Memorandum

TO: Chris Jordan, City Manager
FROM: Chris Kerr, Senior Planner
DATE: December 10, 2008
SUBJECT: LUBA Remand of Office Building at 5750 Hood Street
(AP-08-01)

REQUEST: LUBA Remand of Office Building at 5750 Hood Street

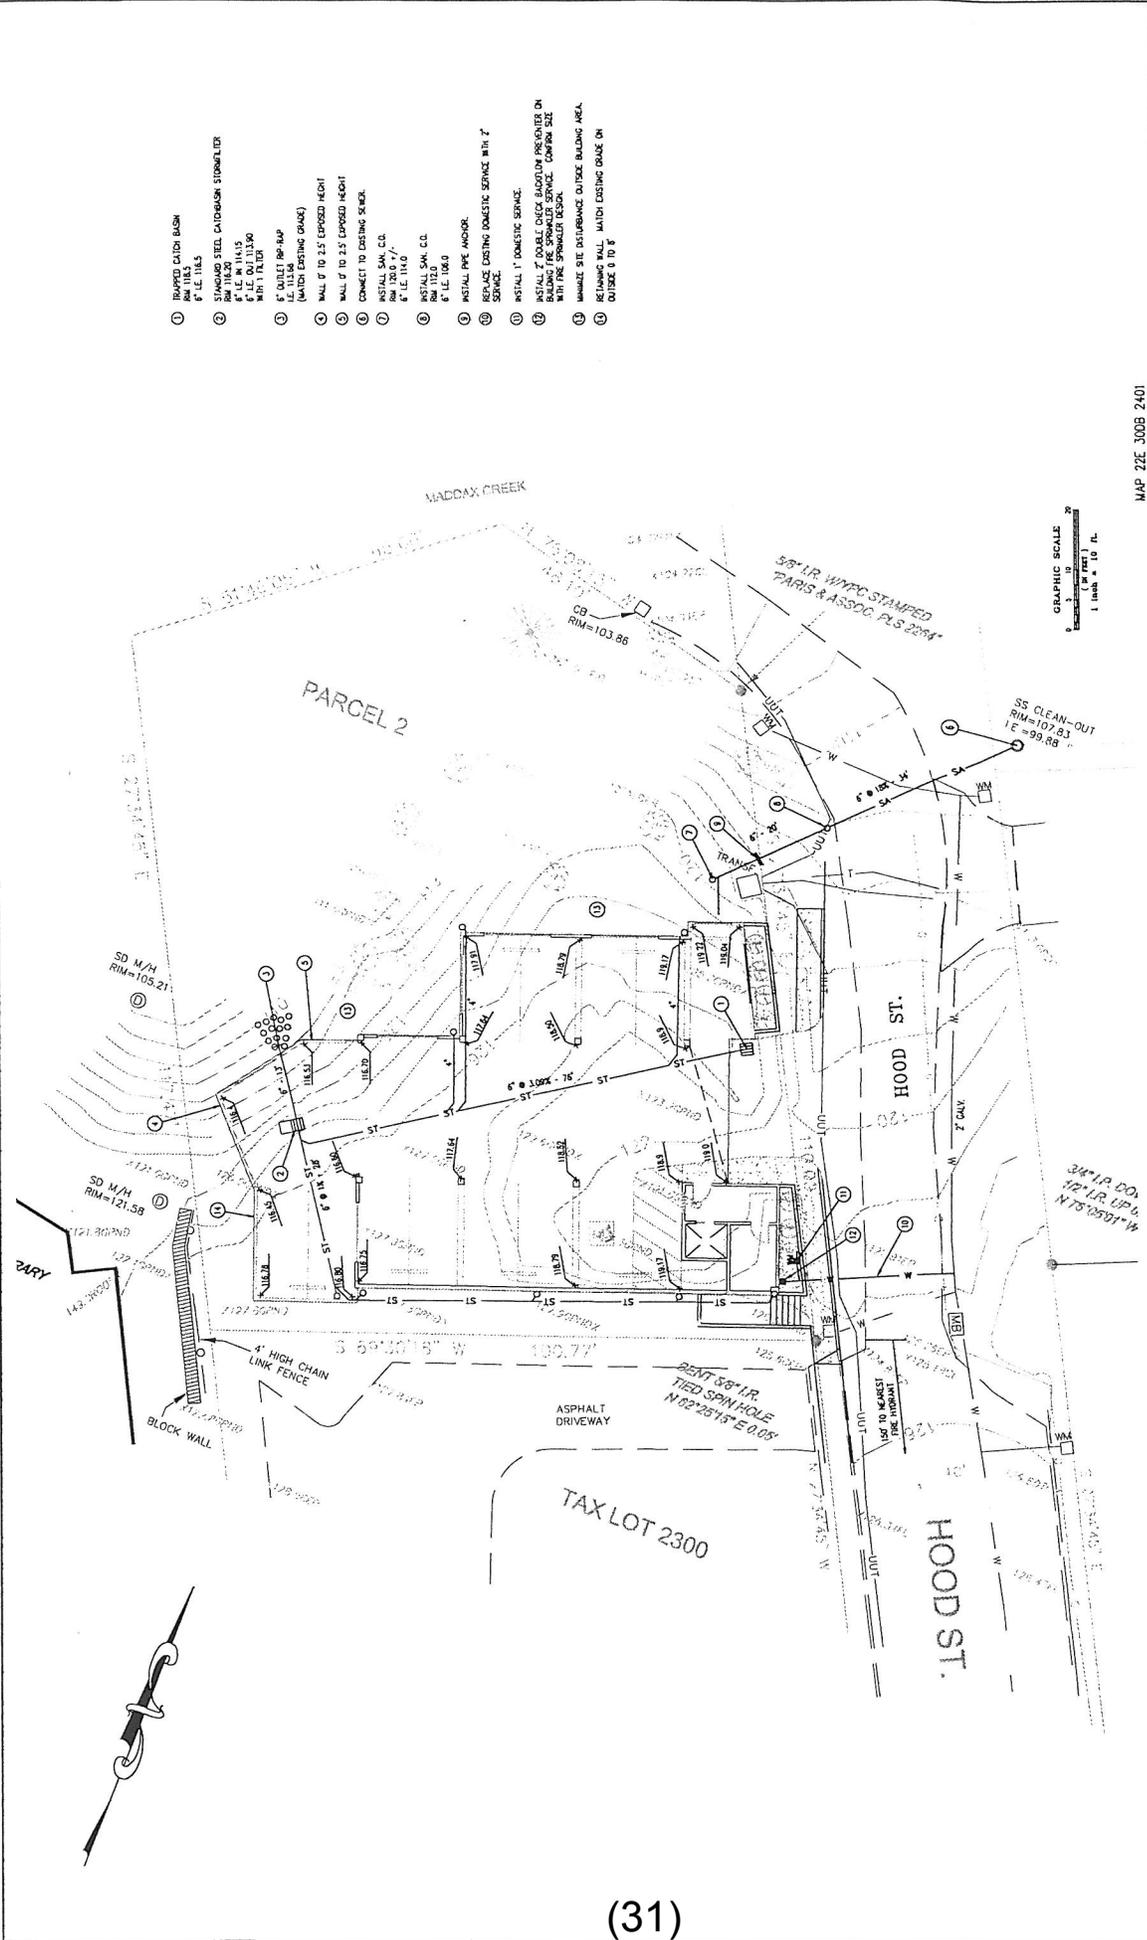
Our revised drawings show use of 4,968 sq. ft. for the developed area, and 30 sq. ft. for drainage outflow. Total 4,998 sq. ft. In the revised drawings, the walkway along the south side of the building which is not required by code, has been removed. The lower retaining wall supporting fill for rear parking and turn around shows a maximum height of 30" above existing grade, and is not attached to the building structure. This wall has been moved away from the library.

ALMA and BILL COSTON OFFICE BUILDING
 5750 HOOD STREET WEST Linn, OREGON
 SITE ANALYSIS and CROSS SECTION

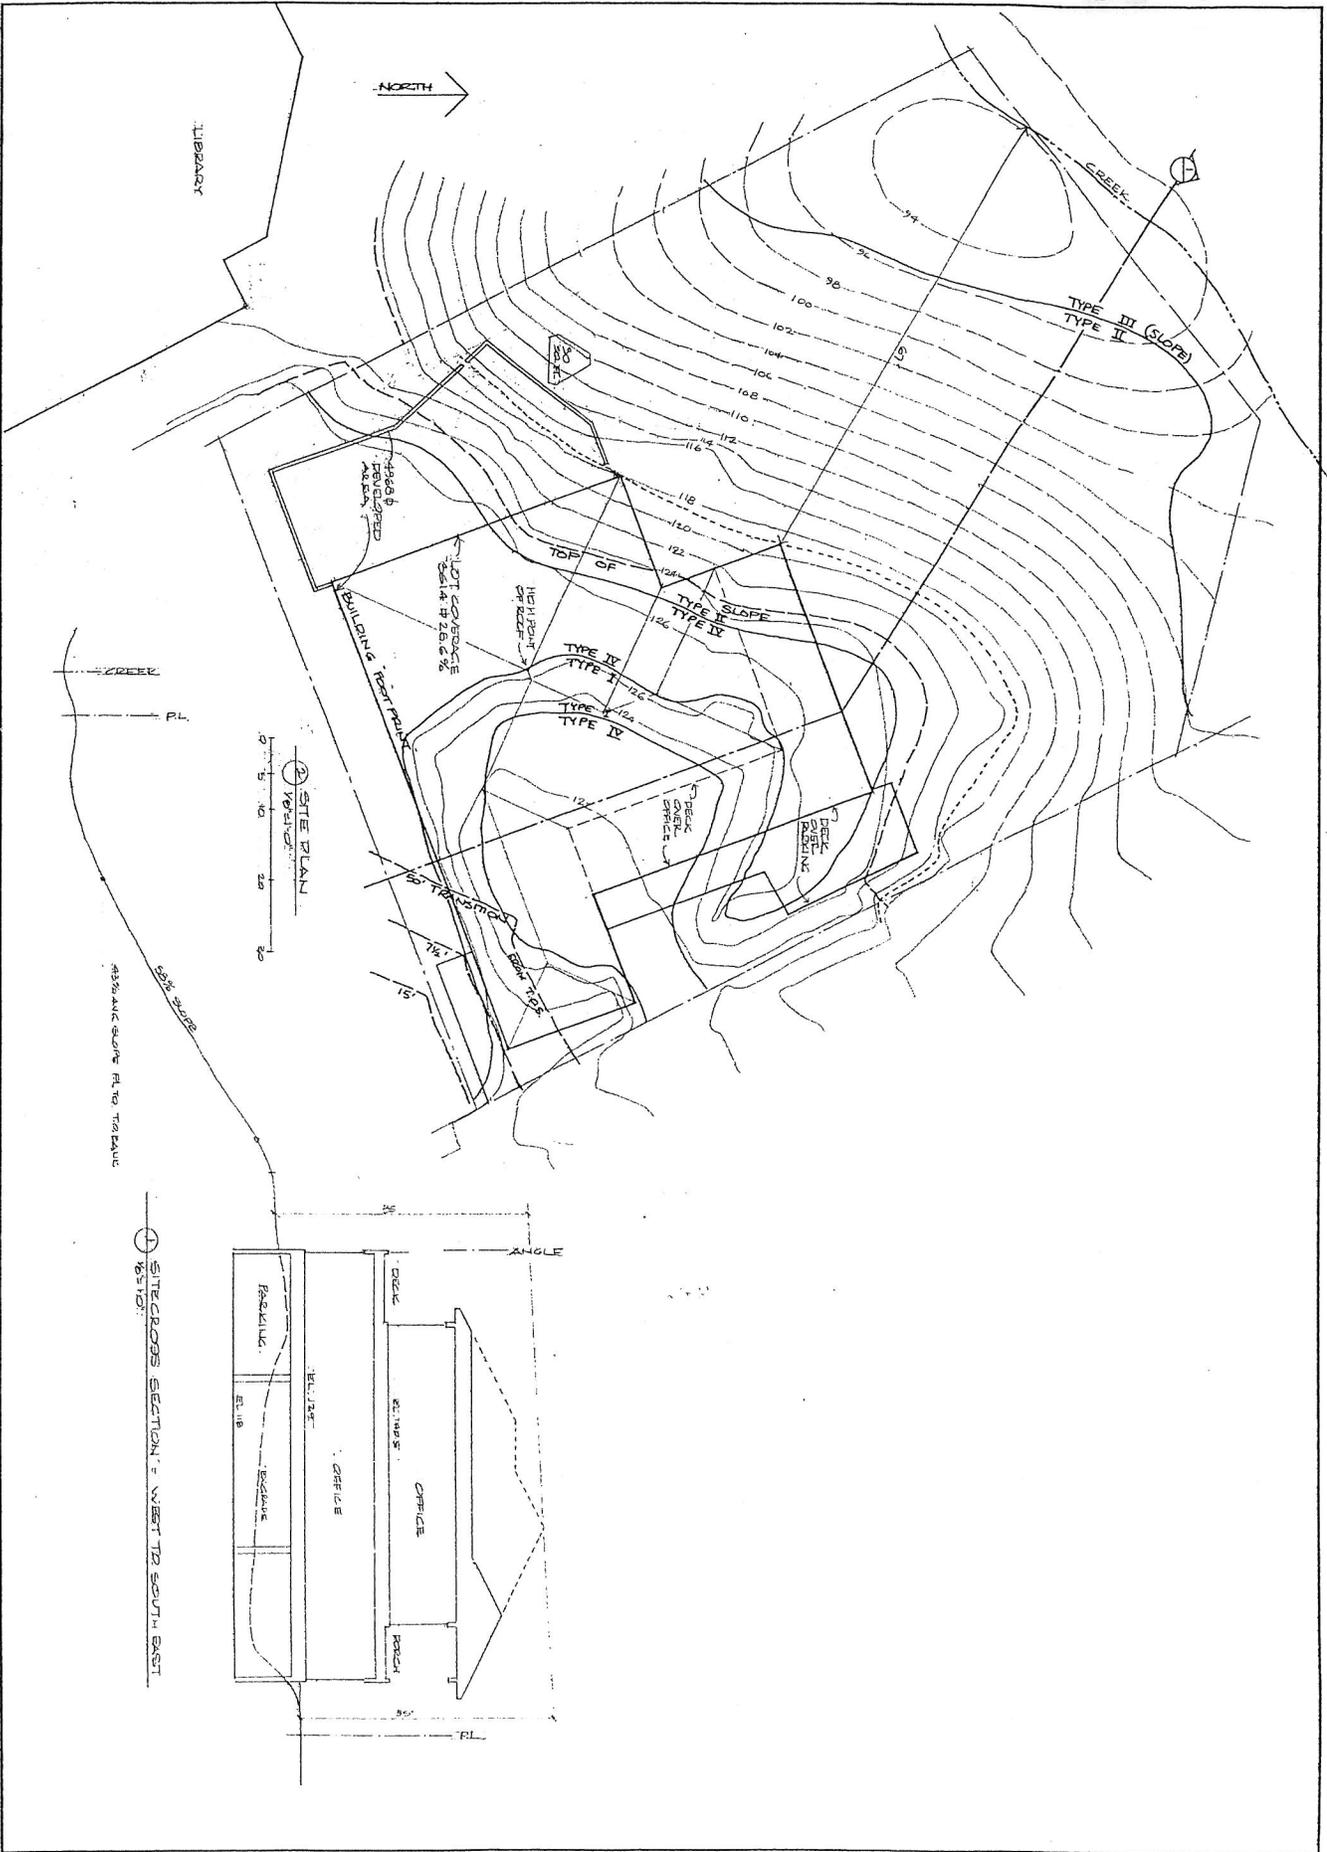
The applicant’s original plan included a surface parking lot to the rear of the building. This lot had two retaining walls, the first on the uphill (south) side and adjacent to the library (west) side. This wall was interior to the proposed parking area, because the parking area is at a lower finished grade than the surrounding terrain. The second retaining wall was on the drainageway (north) side and library (west) side, and was triangular in shape, reaching a height of 10.5 feet at the northwest corner of the parking area and tapering in both directions back to grade. This wall was exterior to the proposed parking area, because the parking area was at a higher finished grade than the surrounding terrain, which slopes steeply at this point into the drainageway.

The applicant’s revised plan keeps the retaining wall on the uphill side of the parking area the same, but has modified the lower part by reducing the turnaround area for cars to the minimum necessary. The resulting retaining wall adjacent to the drainageway has been reduced to a maximum height of 2 ½ feet, or 30 inches. Also, the lower retaining wall is not connected to the building structure, being separated by a small area that is “at grade,” thus not requiring a retaining wall.

1. The parking area and lower retaining wall adjacent to the drainageway should be considered separate structures from the main building. The parking area by itself is the equivalent of a paved driveway to a residential structure, which, even though it may be physically connected to the concrete floor of a garage, is not considered by the City as part of the “structure” for determination of height and setback issues. A paved area and a commercial building are such fundamentally different types of “structures” that they cannot be considered to be one continuous structure.

2. By itself, neither the parking area nor the retaining wall adjacent to the drainageway has a “height” exceeding 30 inches. Using the city’s standards for measurement of height, the base grade of both these structures is measured five feet in front (east) of the parking lot, since the lowest point does not exceed the highest point by more than 10 feet. This base datum is 116.4 feet.

3. The parking area, being flat, is not a structure since it has a height of zero as compared to the base datum of 116.4 feet. Similarly, because the retaining wall extends downward from the parking area, it too has a height of zero and is not a structure.

4. Alternatively, staff has determined that the retaining wall adjacent to the drainageway would qualify as an “accessory” structure, allowed up to 3 feet from the rear property line. The structure has a height of less than 15 feet, is less than 500 square feet in size, and is more than 60 feet from the front property line. The paved parking area itself does not qualify for the reduced setback allowed for an “accessory” structure, because it is greater than 500 square feet in size.
